MINUTES – ORDINARY MEETING

191/17 PLANNING APPLICATION P17-030 : WELLINGTON STREET ROAD RESERVATION, LONGFORD

This report assesses an application for Wellington Street road reservation, Longford to construct a Parklet outside LINC (heritage precinct).

Site Plan

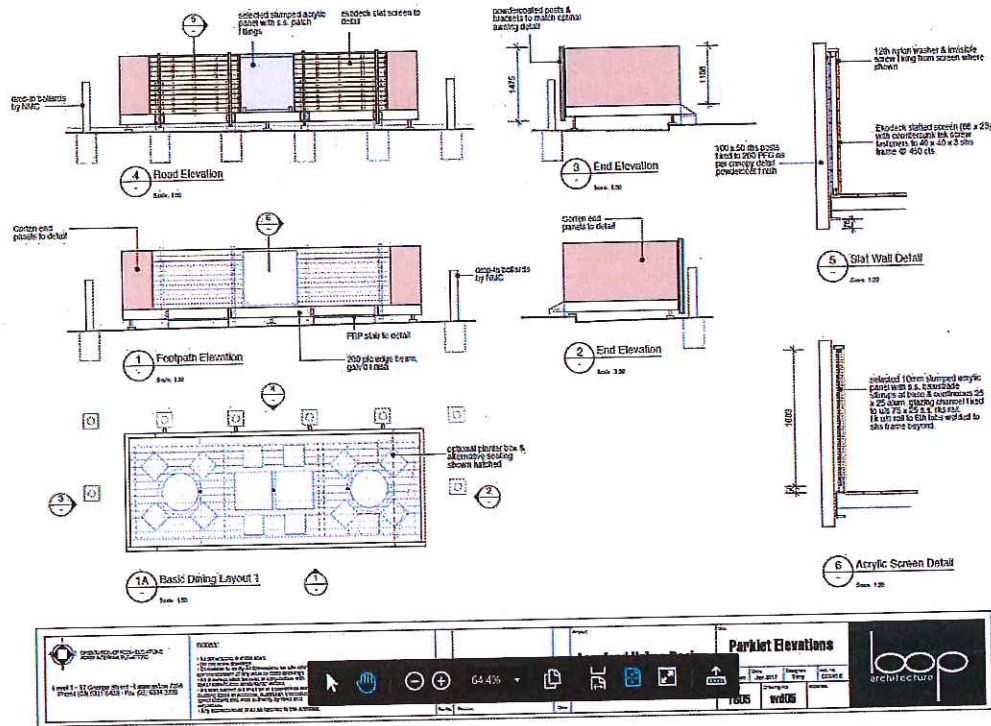
- The application is unclear in terms of where the parklet will be positioned in relation to the footpath.

Planner's comment:

The site plan clearly delineates the location of the parklet in relation to the footpath.

Elevations

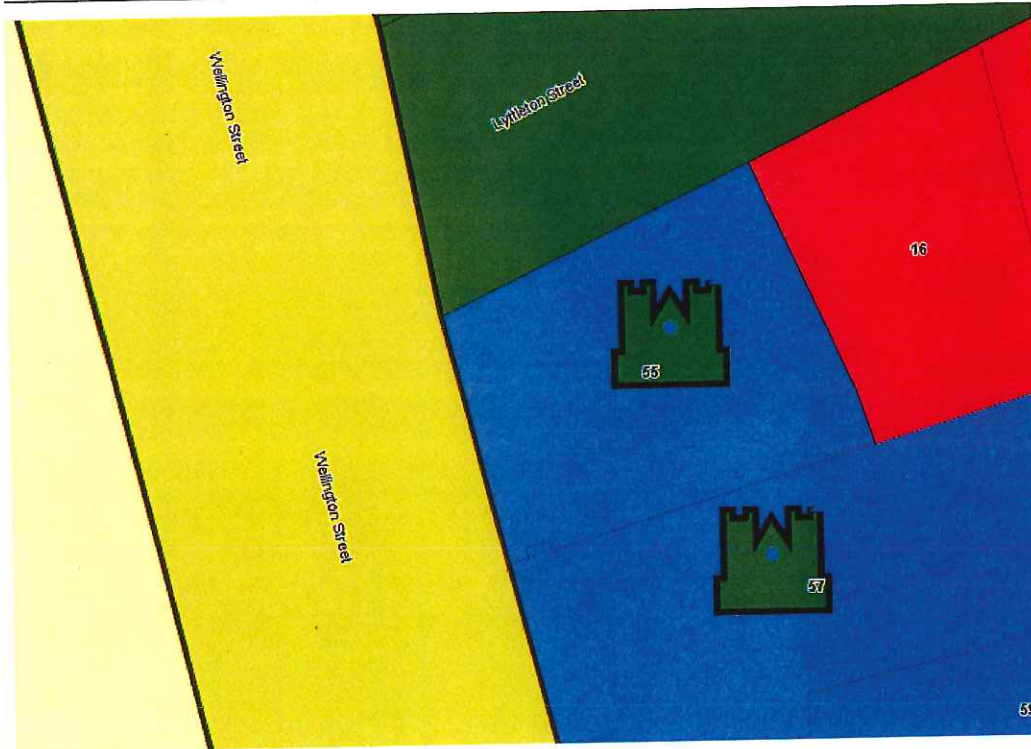
- The proposed works would compromise the heritage values of the streetscape.

Council's Heritage Advisor has provided an assessment against the Heritage Code and the Heritage Precinct Specific Area Plan and determined compliance subject to a recommendation that the façade slats be erected vertically and be of a dark grey tone. It is noted that the parklet is a demountable structure and will not permanently and irreparably alter the heritage streetscape.

Comment: Meets the Acceptable Solutions. I recommend that the Eco-deck slats be in a dark grey colour.

Before the development commences an Amended Plan must be submitted (P3 – Elevations) showing:

- The eco-slats being laid in a vertical alignment and finished in a dark grey colour to the satisfaction of Council's Heritage Advisor.
